**Flood Control Project Maintenance  
Levee Inspections**

**Fall 2013 Levee Maintenance Deficiency Summary Report**

**Reclamation District No. 0501 Ryer Island**

Levee Mile Report Line	85
Start Levee Mile	3.02
End Levee Mile	3.09
Location	Water Side
Category	Supplemental
Item	USACE Erosion Survey
USACE 2012 Photo #1	
USACE2013_STM_18-8_R_1.jpg

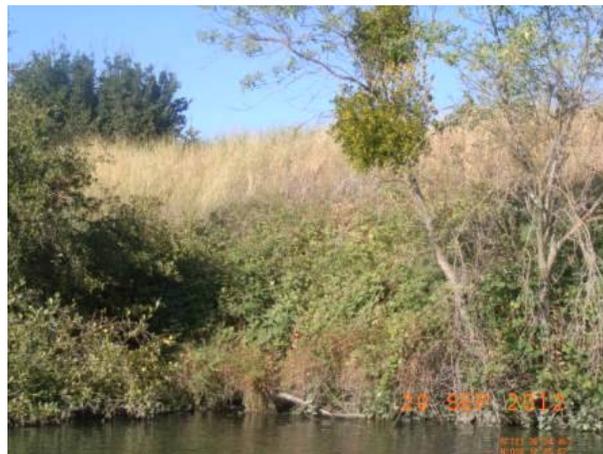
85	3.02	3.09	Supplemental	USACE Erosion Survey	WS	M Ma	Inspector Comments: 2000 - Slow erosion of lower and mid-slope with rock bench at the low water line. 2012: No observed change. [2012 Site ID: STM_18-8_R]	38.212573 ° -121.609760 °	38.211596 ° -121.609928 °	28 Y
DWR ID:

Levee Mile Report Line	90
Start Levee Mile	3.13
End Levee Mile	3.13
Location	Land Side
Category	Supplemental
Item	DWR UCIP Field Study

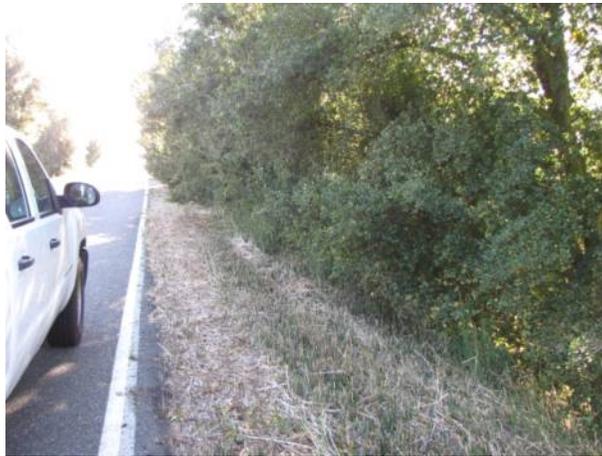
Overview of landside
